AURIX™ TC37xEXT errata sheet

Marking/Step: (E)ES-AB, AB

About this document

Figure 14 Package Outlines LQFP-144 for TC37xEXT

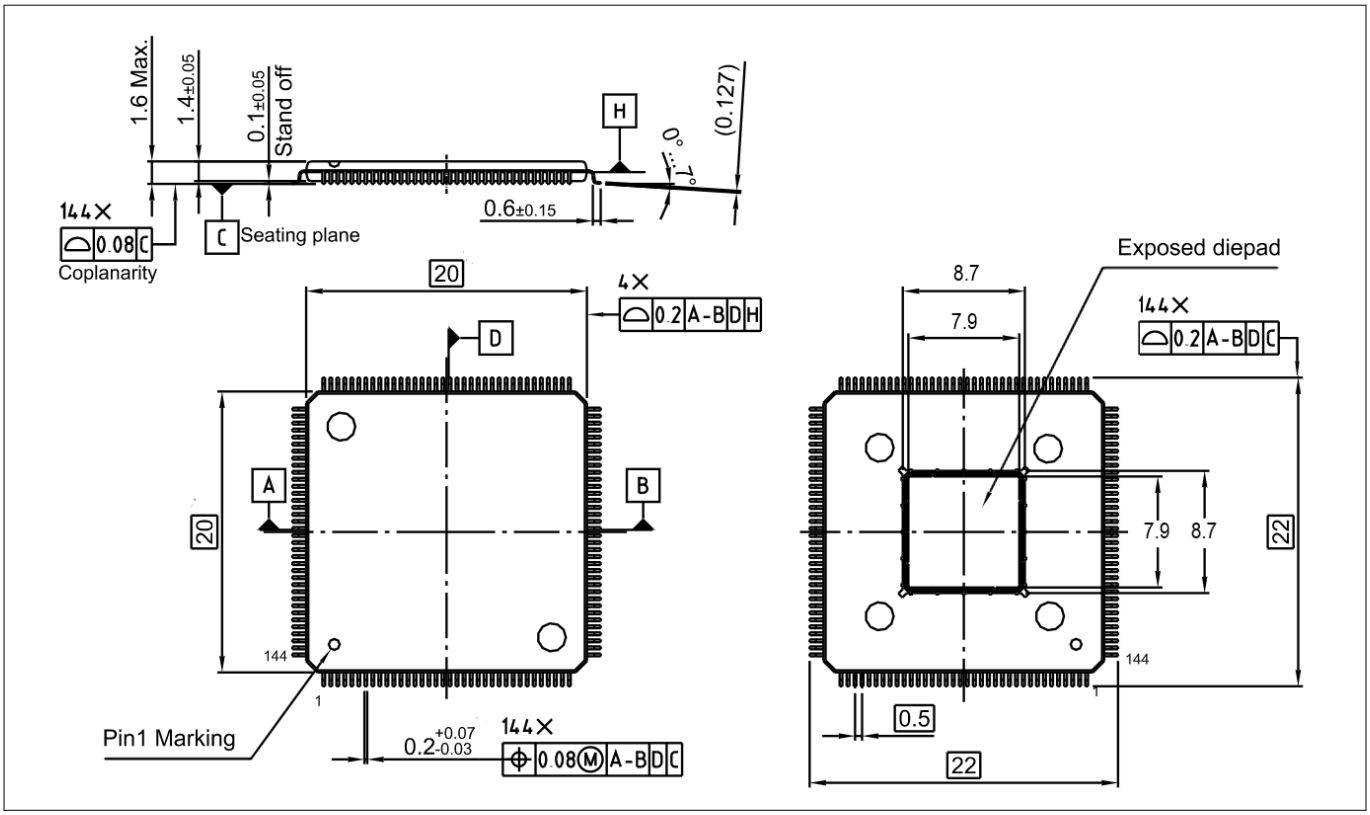
This information shall substitute the corresponding information in the TC37xEXT AB-step Data Sheet V1.1.

***Note**: For the exposed diepad of the LQFP-144 package of the TC37xEXT, structural corner protrusions have to be considered for purposes of system design and integration with a maximum boundary of 9.4 mm.*

Figure 15 Positive overload on P-pad of a LVDS RX pin pair (both used as inputs)

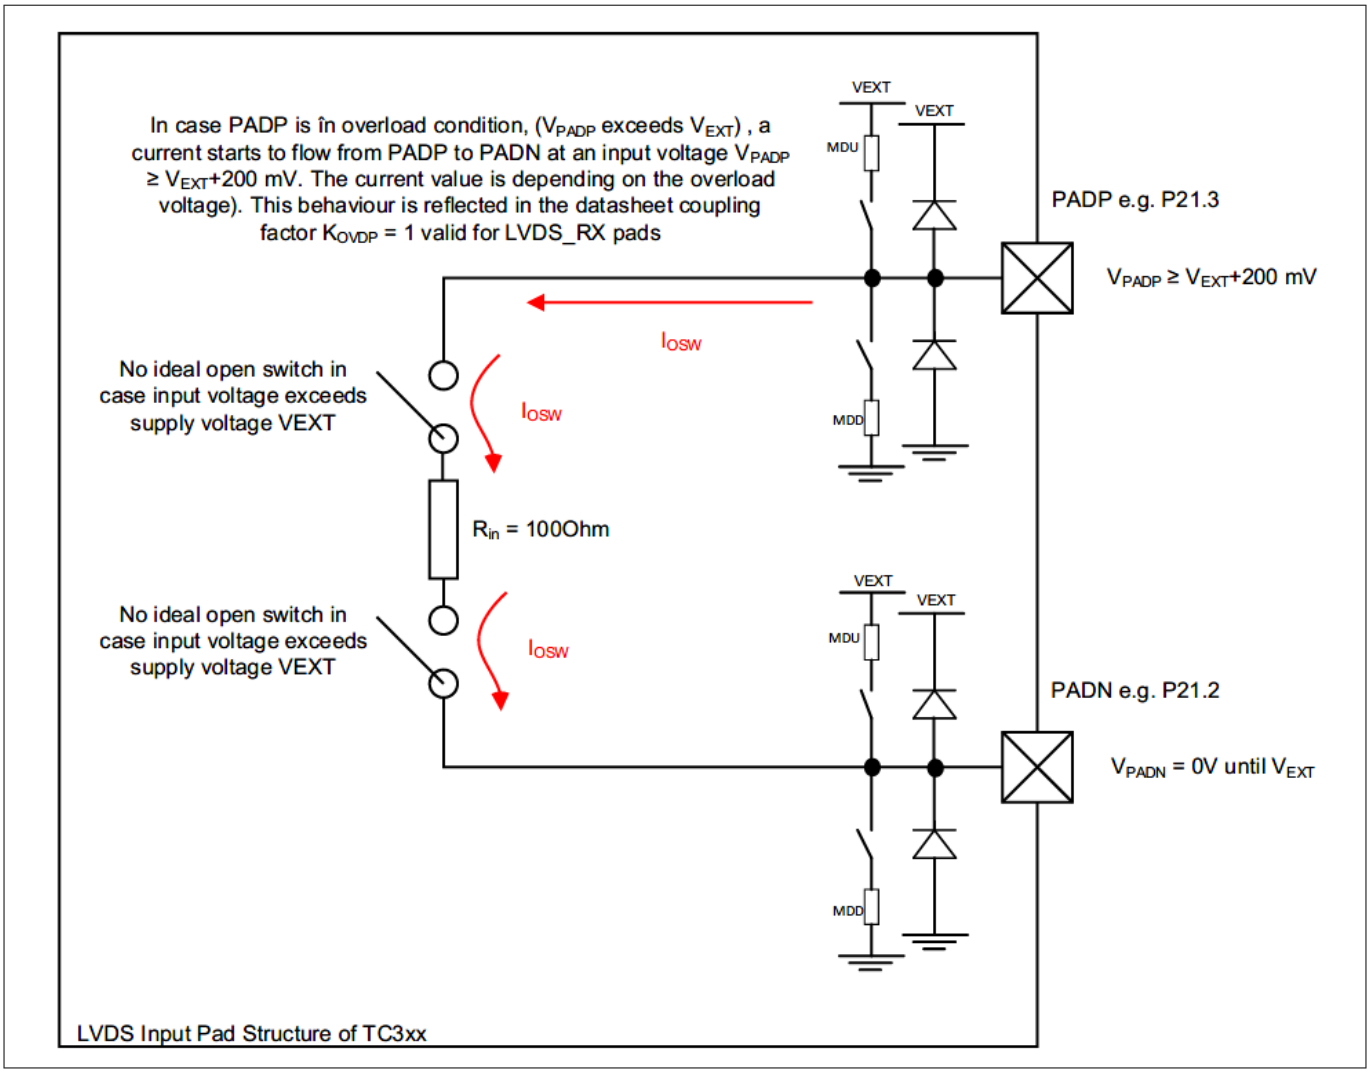
The following figure illustrates the effect for a positive overload condition ($V_{PADP} > V_{EXT}$) on the P-pad (PADP) of a pin pair where both the P-pad and the corresponding N-pad (NPAD, with $0V \le V_{NPAD} \le V_{EXT}$) are used as digital CMOS inputs.

The overload current I_{OSW} through the non-ideal open switch significantly increases when $V_{PADP} \ge V_{EXT}$ + 200 mV.
